CAPE COD COMMISSION

RE: Development of Regional Impact Hardship Exemption
Cape Cod Commission Act, Section 23

Project: Excel Switching Corp Corporate Facilities
Perseverance Way and Gonsalves Avenue
Hyannis, MA

DECISION OF THE CAPE COD COMMISSION

TURNING RADII SKETCH PLAN

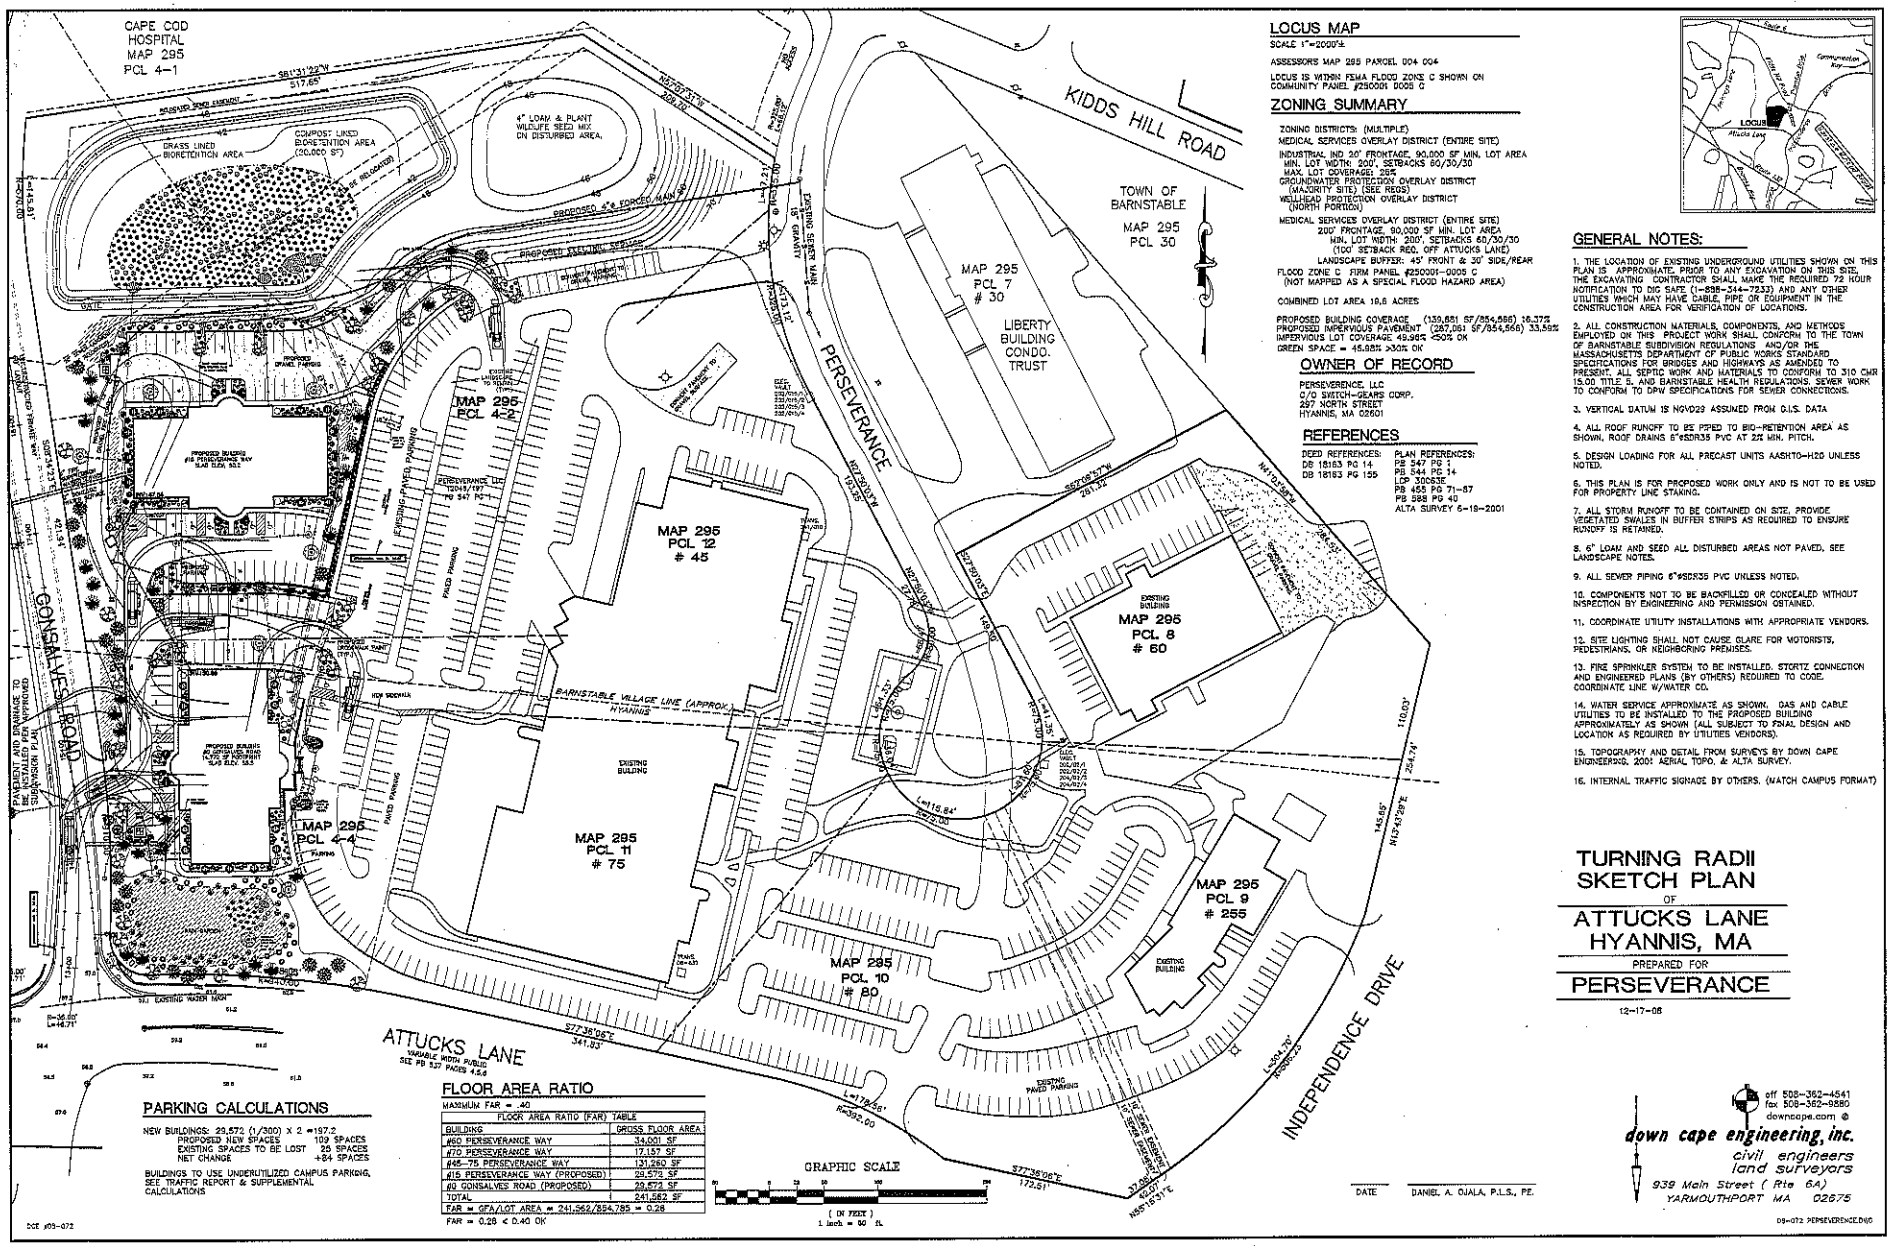
Chief Crosby noted that the parking lot 'tree islands' were not on the plan he was given. He stated that the radii might not be adequate to allow fire truck access, as tractor-trailers can bend/turn in middle and fire trucks cannot. He stated he would like more time to review this newly proposed plan. He noted that the applicant's project is not in an office space but more of a medical services district and has concerns about the intersection becoming overburdened with development due to Excel and Cape Cod Healthcare. He stated his desire to maintain access to Gonsalves Road, which provides access in and out of the facility and would like to require complete build out.

Mr. Pfautz stated that the fire department would like to go on record as having concerns about one of the parking areas being a dead end. The dead end would require having a fire truck back out, which is difficult. Mr. Pfautz suggested putting in a ramp to tie the two parking lots together, noting a four-foot elevation change between them.

Mr. Ojala added they would like to resolve this sooner rather than later and requested that language be added in the decision that if they add a second cut through they won't need to come back to the Commission for approval. Mr. Bornstein stated all the buildings have standpipes and sprinklers and provide clear access on three sides.
